Randwick Local Planning Panel (Electronic) Meeting

Thursday 24 October 2024

Development Application Report No. D86/24

Subject: 80 Doncaster Avenue, Kensington (DA/799/2024)

Figure 19: Expanded west elevation, including sun angles from the north adjacent RFBs (Source: Studio GA, dated June 2024).

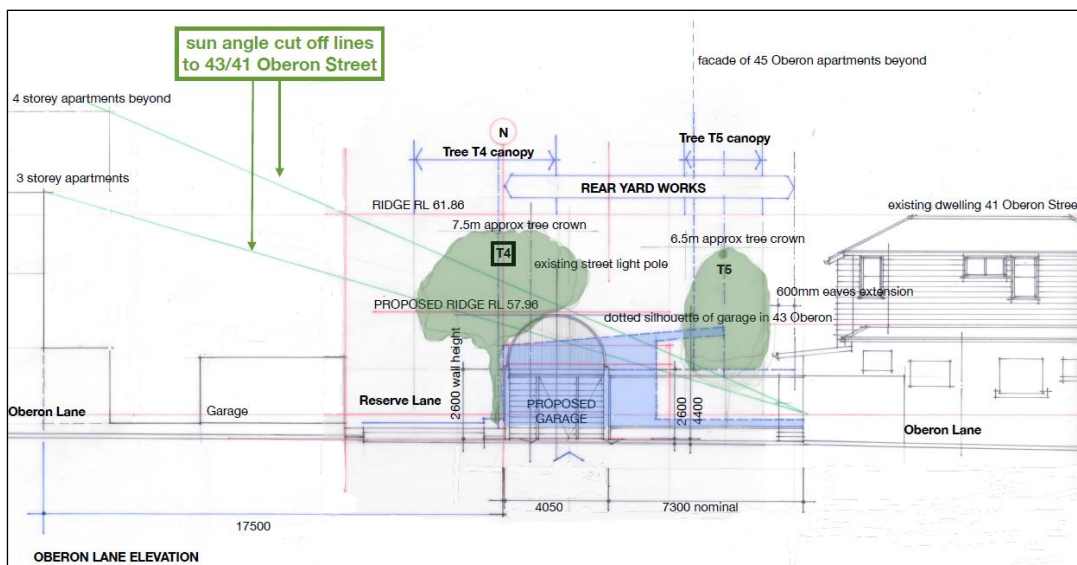
The key issues raised are that the taller roof height of the proposed structure, when compared to the existing garage, would result in overshadowing to their private open space, as well as to the north-facing sliding doors to their open plan kitchen and dining room within the dwelling.

In response to the submission, the applicant provided elevations that a large portion of existing shadows cast are the result of the adjacent three-storey and four-storey residential flat buildings to the north, which alter the angle at which the site receives direct sunlight.

When considering the above, it is considered that the apartments to the north will have a great impact than the garage. However, the RFBs are in a fixed position, and when the sun moves to the west in the later afternoon, the RFBs will have no impact. It is considered that hourly shadow diagrams at midwinter are required to determine whether the proposed garage allows the neighbouring private open space and living area of No. 43 Oberon Street would comply with the solar access provisions of the RDCP 2013.

Figure 20: Extract of Garage floor plan (Source: Studio GA, dated 24.08.2024).

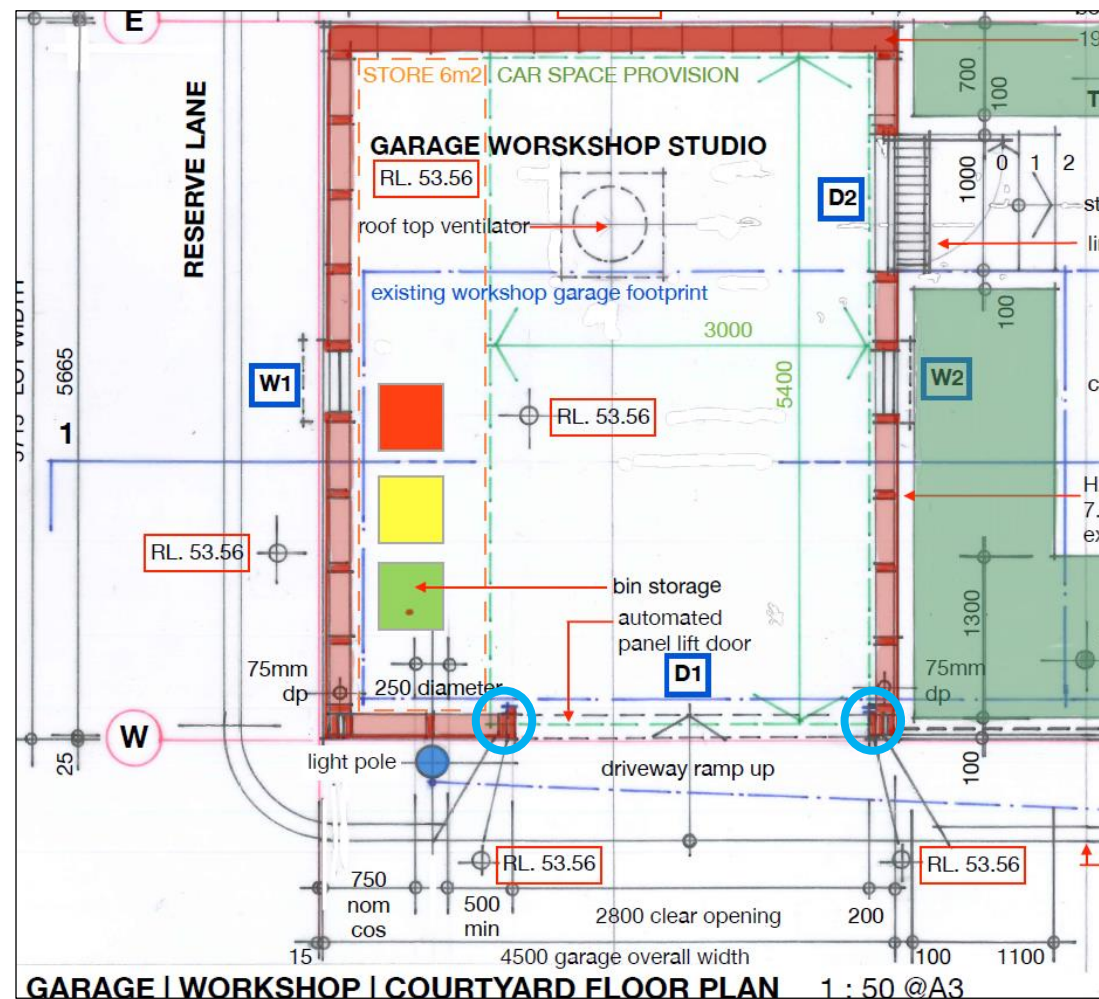
The initial comments received from the Council's Development Engineers raised concerns about the proposal not complying with the internal garage dimensions along with a garage door that was too narrow and too close to the Ausgrid power pole, as discussed earlier in this report.

Additional information was received, which increased the setback from the Ausgrid power pole to 500mm as per Ausgrid's request and increased the garage door width to 2.8m. However, a review of the additional information submitted found the required 3m x 5.4m shown on the garage plan includes areas obstructed by the western side wall of the proposed outbuilding as circled in blue below:

Further concern is raised that the current design hinders the maneuverability of people entering and exiting their vehicles from the car space. The floor plan above shows bin storage and storage area to be located directly next to the car space; this in turn would inhibit the type of vehicle that residents can comfortably park with enough room to enter and exit their vehicles. There is also a concern that once people exit the vehicle, they would be unable to actually exit the garage. For example, if a large car is used by the residents, which has a length of close to 5.4m, no people exiting the car on the northern side of the garage would be able to exit the garage. The size, orientation, and layout of the garage is inappropriate.

Council GFA Calculations (inclusions in blue):

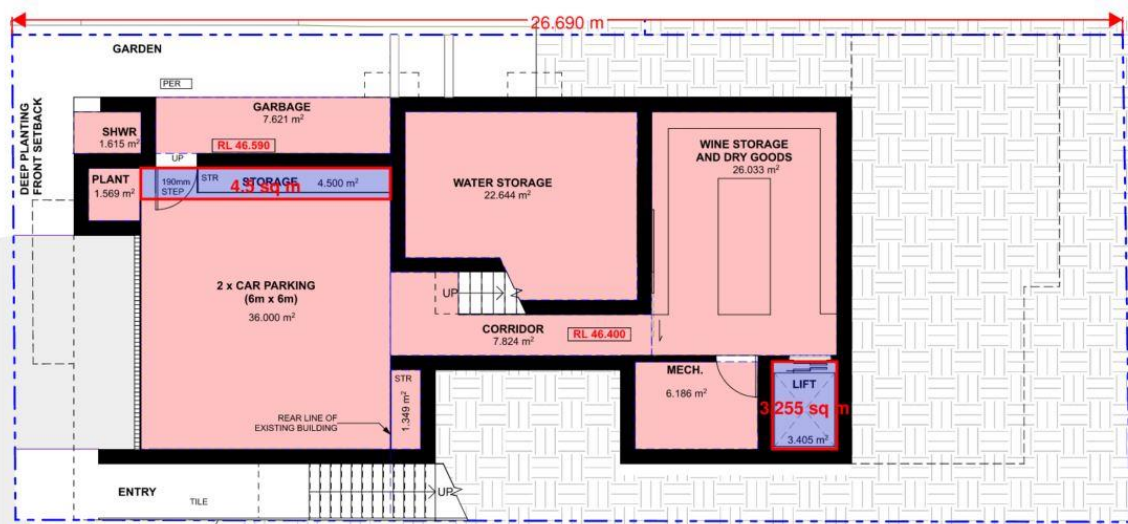
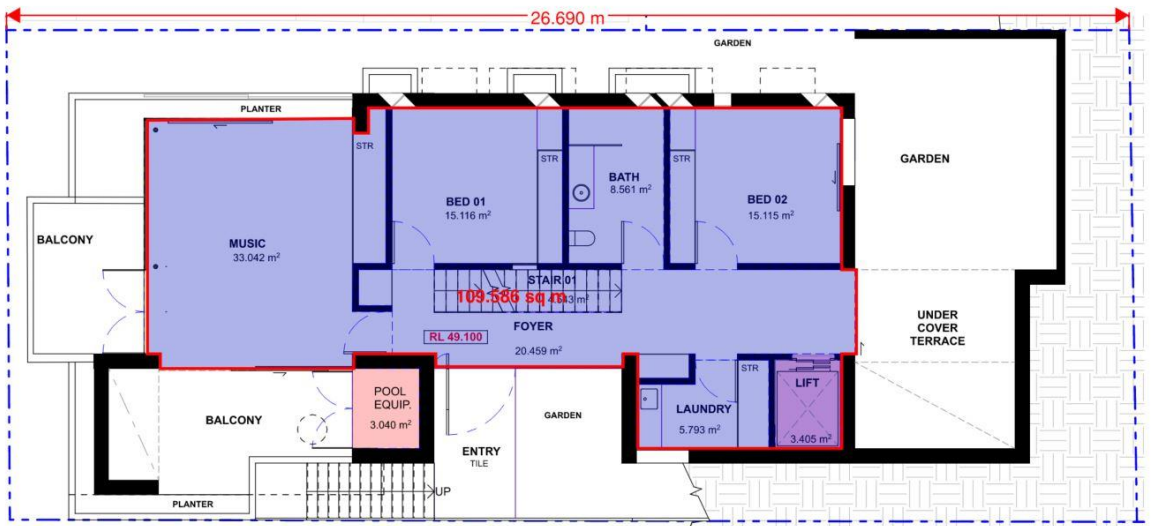
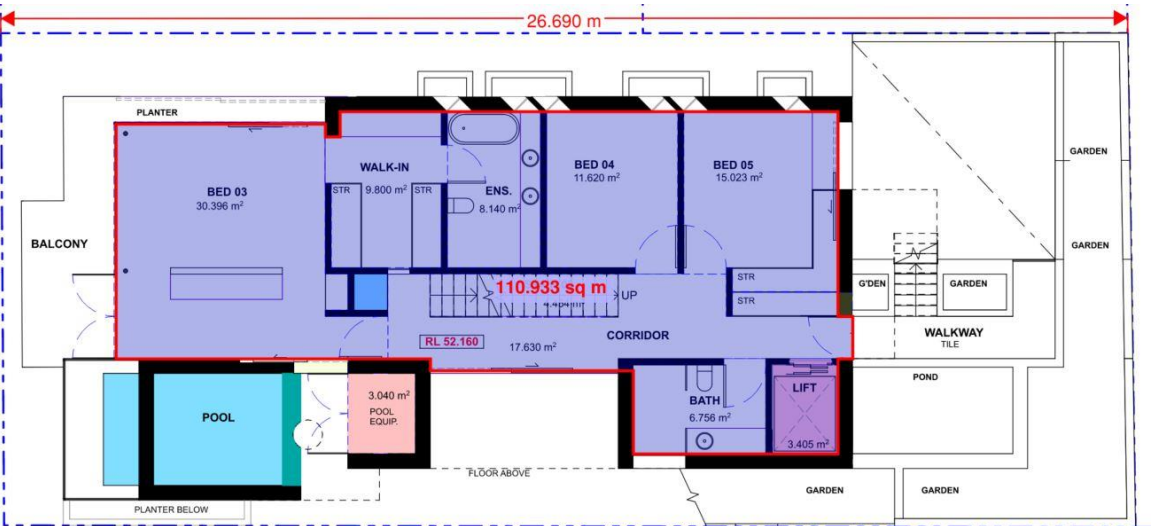
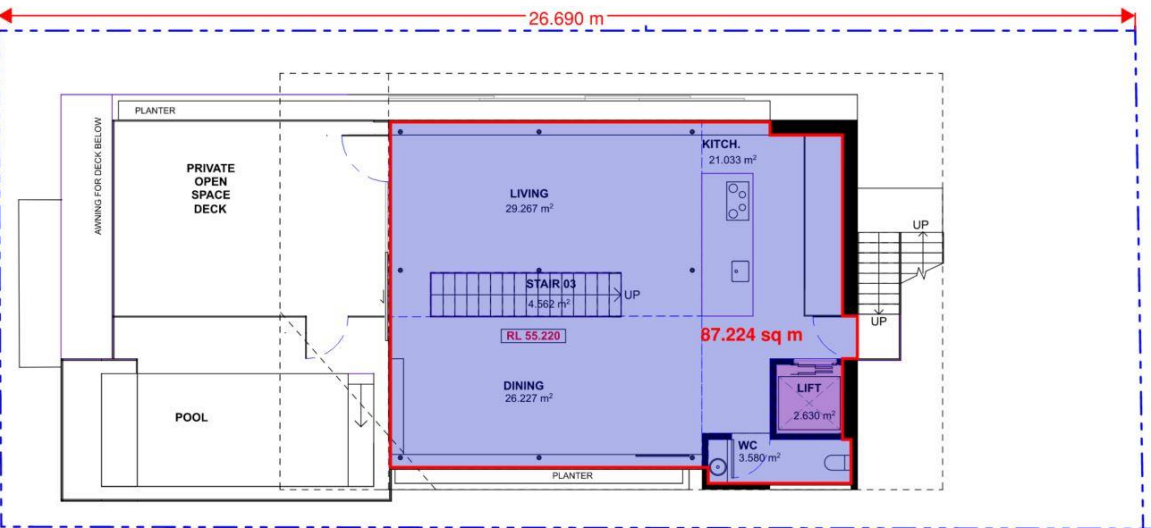
1. Has the Applicant's written request demonstrated that compliance with the development standard is unreasonable or unnecessary in the circumstances of the case?

Figure 27: Western Elevation (Source: Burrow Architecture)
Measurements in red by Council Assessment Officer

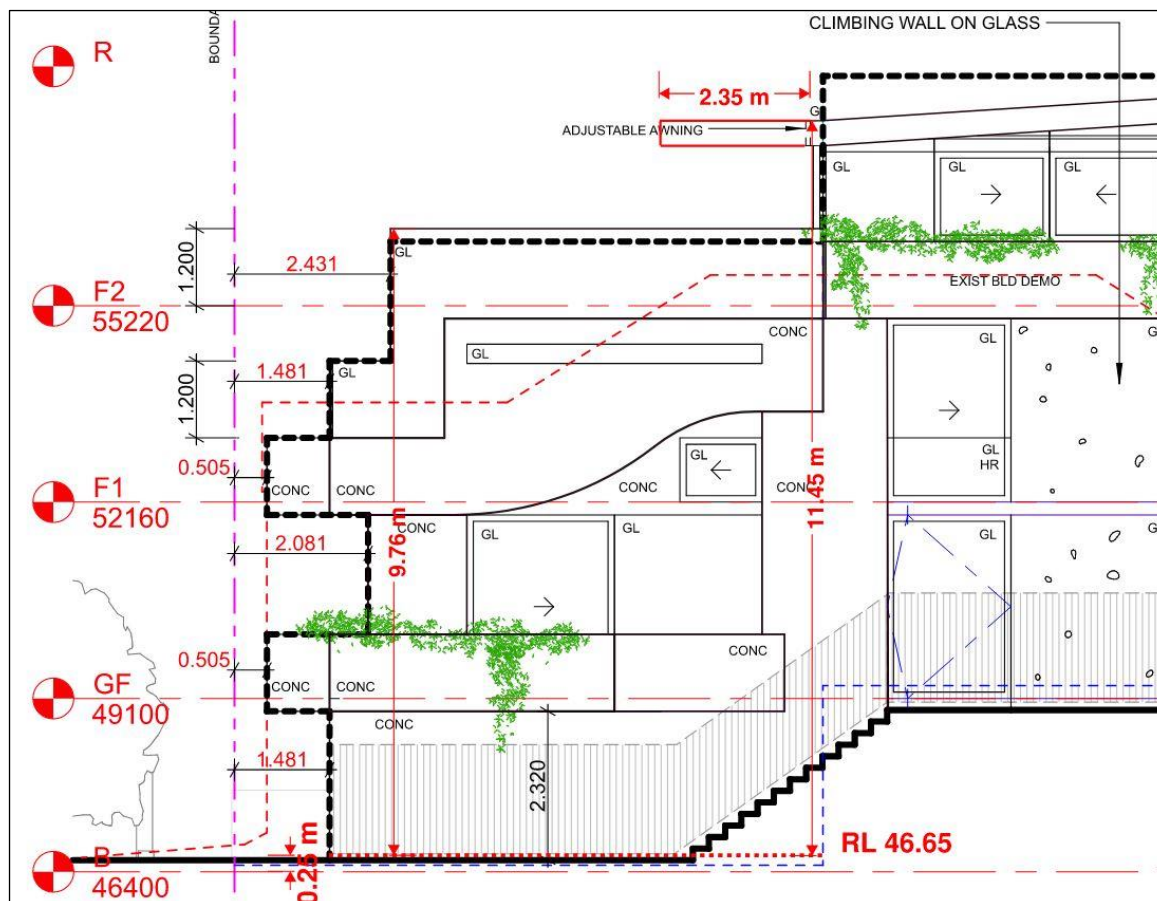
The building height is measured from the existing ground levels at any given point on the site. The existing lower ground floor has an RL of 46.85, if the floor slab is 200mm thick this yields an existing ground floor of RL 46.65 for this area. The fascia and proposed adjustable awning are 11.45m above this point. The 2nd floor private open space deck also exceeds the control, with the glass balustrade at a height of 9.76m above ground level (refer Figure 27).

Given that the proposal involves a new dwelling house, any height breach in this circumstance is not considered supportable. The letter requesting the application be withdrawn, refer to Relevant History section above, highlighted this non-compliance with Clause 4.3 Height of Buildings within the LEP. A Clause 4.6 exception to a development standard request has not been provided.

Figure 28: Section BB (Source: Burrow Architecture)
Measurements in red by Council Assessment Officer

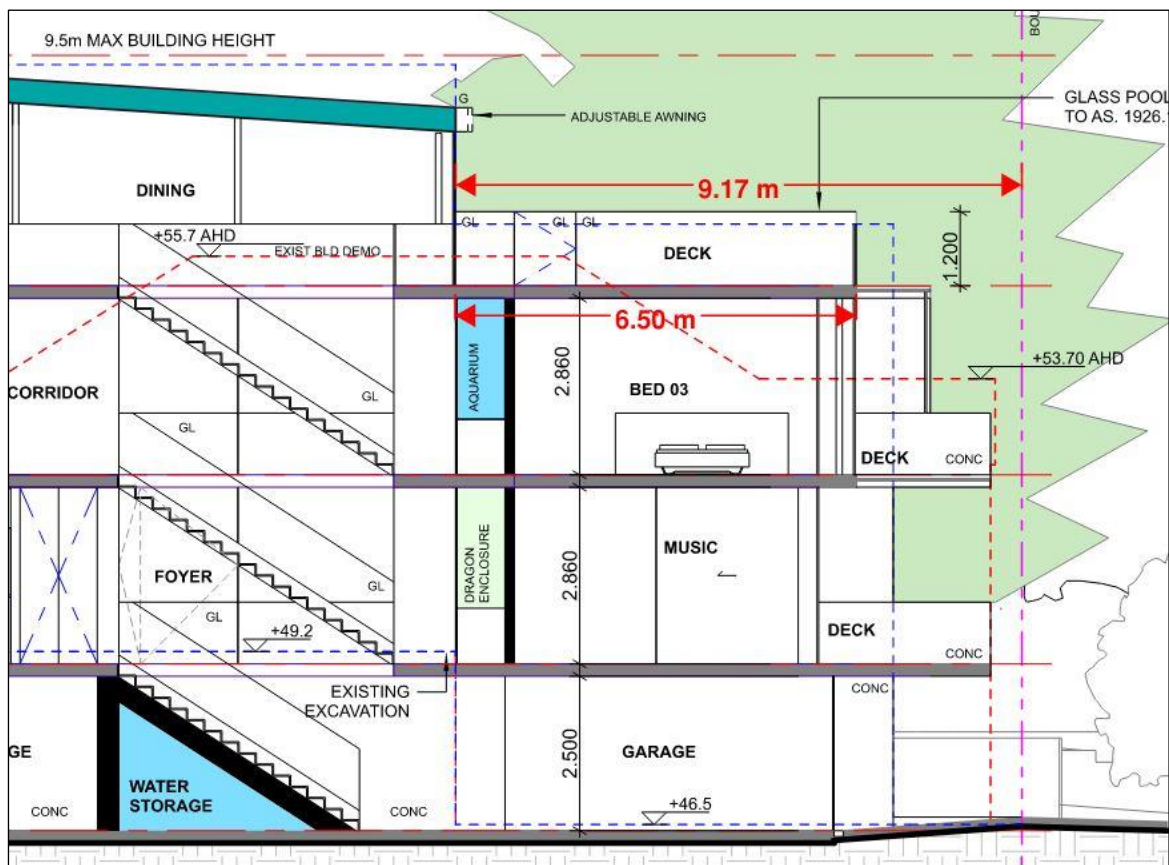
The proposed new dwelling presents as bulky, excessive part three-storey, part four-storey building that is not compatible nor consistent with the prevailing streetscape and development pattern of the R2 Low Density Residential zone. It thereby fails to meet the objectives of Section 3.2. While the proposal is for a four-storey dwelling, it is acknowledged that the top storey interior is setback approximately 6.5m from the interior of the storey below and so will not present as a four-storey development from the street (refer Figure 28).

Figure 29: Northern Elevation (Source: Burrow Architecture)
Setback non-compliance in red by Council Assessment Officer

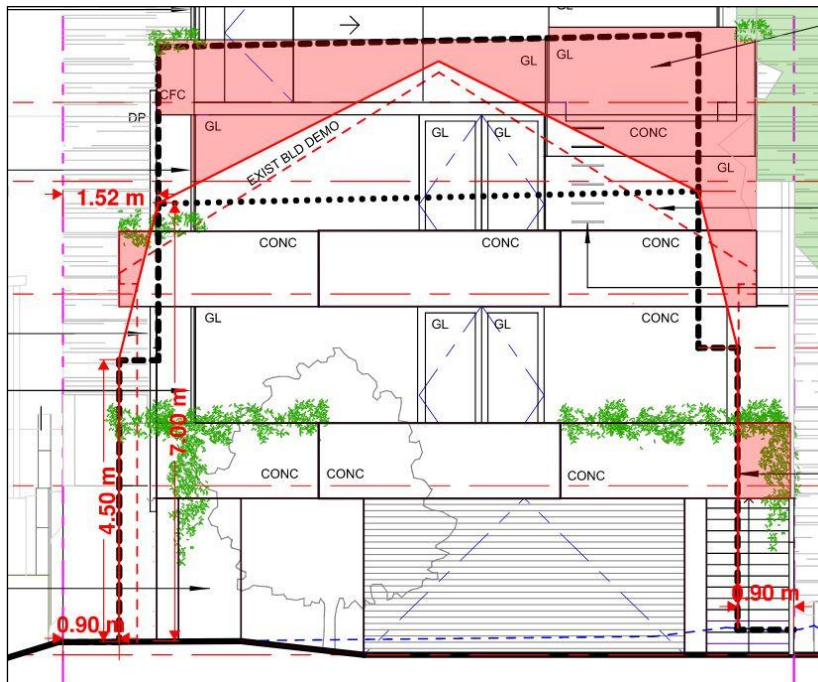
As with the previous comments on building height, the side setback non-compliance results in unnecessary bulk, scale, and visual impact as viewed from the street and from neighbouring dwellings in addition to overshadowing and visual privacy impacts that are discussed further below. For Council to support the proposal it would have to be re-designed to substantially reduce the bulk and scale to comply with Council's building envelope controls.

Figure 37: Section EE (Source: Burrow Architecture)

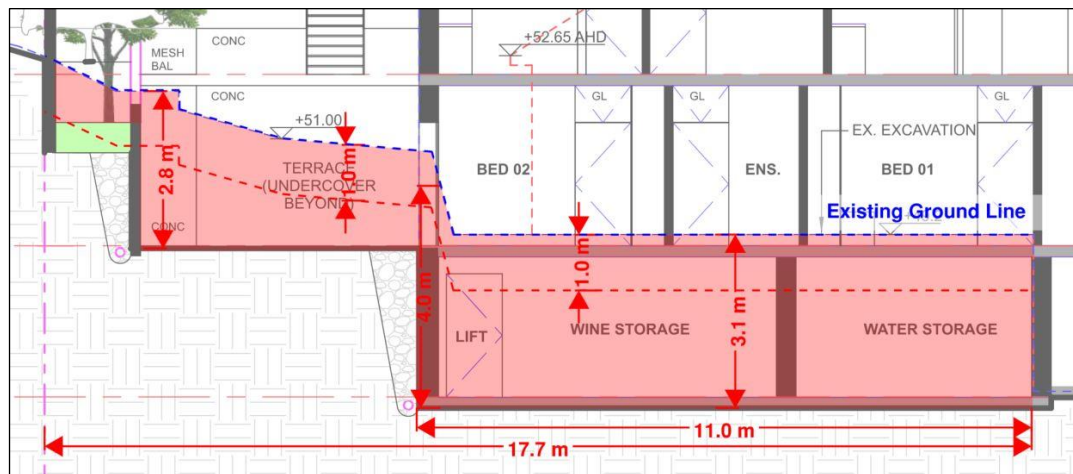
The proposed development involves substantial earthworks (excavation) that are not compliant with relevant sections of the LEP and DCP. This excavation is caused by the proposed basement level, that involves 3.1 metres of excavation, and the sunken terrace garden to the rear which involves 2.8 metres of excavation (refer Figure 37).

Figure 38: Split-level design (Source: Randwick DCP 2023)

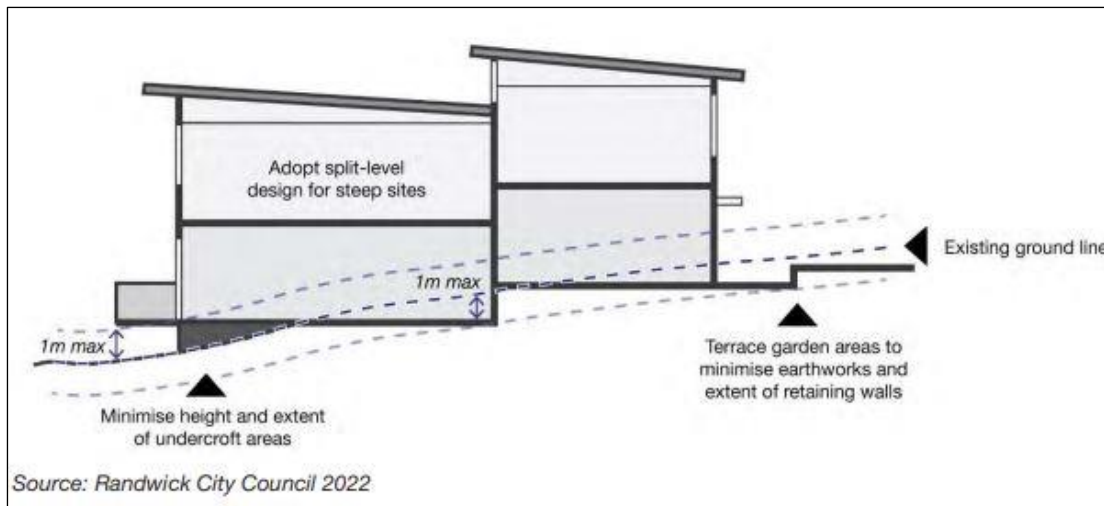
A more site responsive design that respects the existing topography and unique site constraints, should be adopted. The inclusion of internal ramps and/or steps to facilitate a built form that steps with the existing topography may be required to facilitate this (refer to Figure 38).

Figure 39: 2nd floor private open space deck (Source: Burrow Architecture)

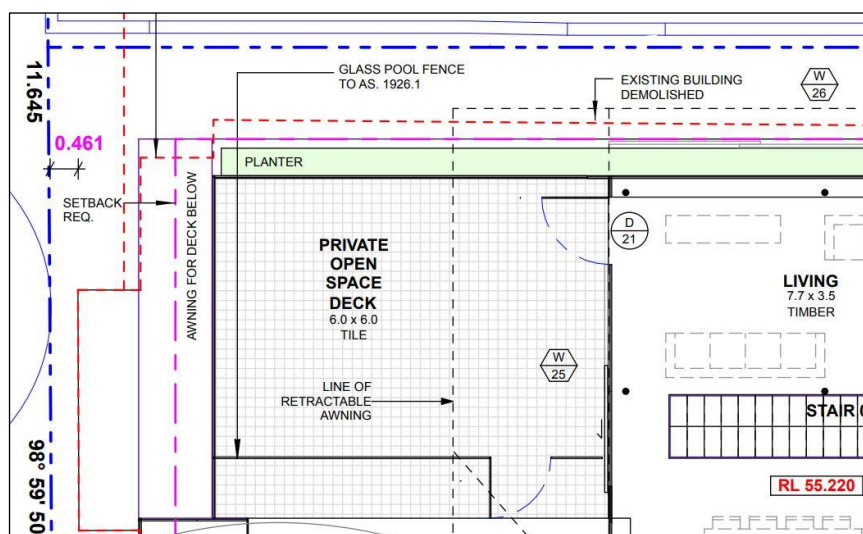
The deck is an excessive 6m x 6m and overlooks the private open space of No.6 Dundas Street (refer Figure 39). As established, the deck is designed as the primary private open space of the dwelling. The rooftop terrace also includes a retractable awning that is included on the roof plan, the full extension of which is not indicated on the elevation or section drawings (refer Figure 40 & 41). As discussed, the building height of this deck exceeds the 9.5m LEP development standard.

Figure 42: Shadow diagrams (Source: Burrow Architecture)

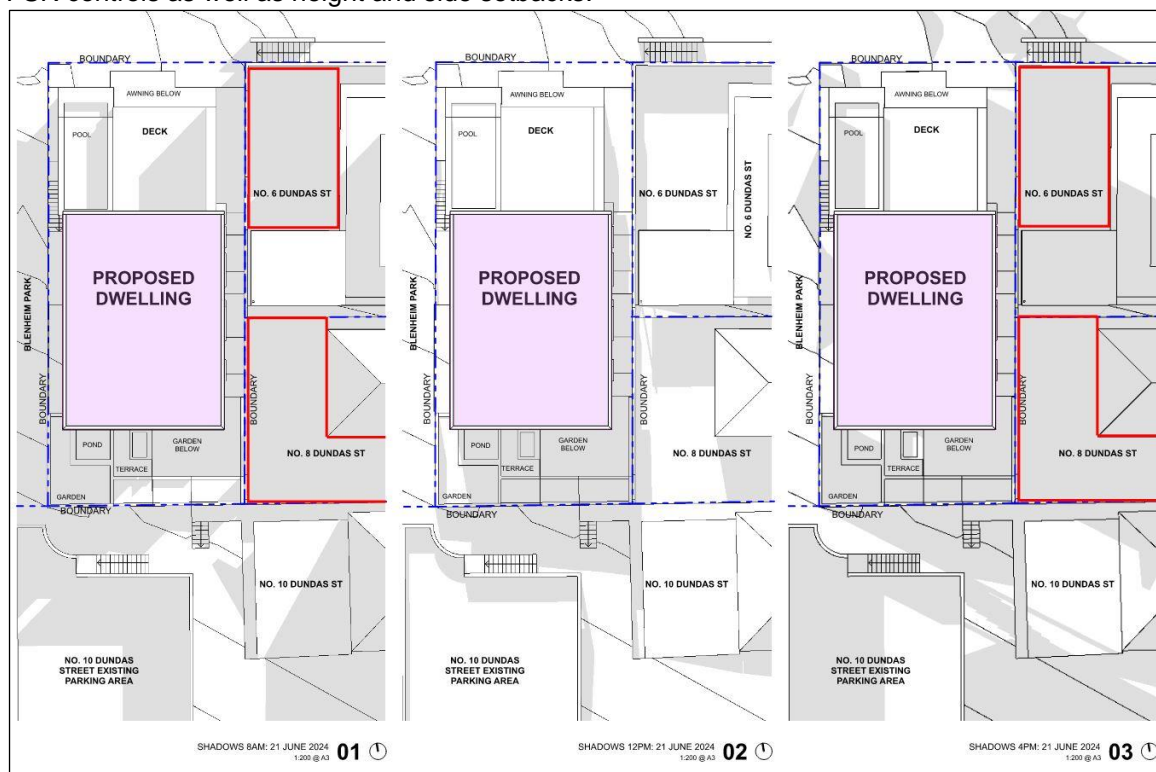
The shadow diagrams provided with the application (refer Figure 42) show that the proposed garden, the only private open space at ground level, to the rear of the site is completely overshadowed by the dwelling. The proposed private open space on the elevated 1st floor deck does not meet the criteria for contiguous private open space within the DCP.
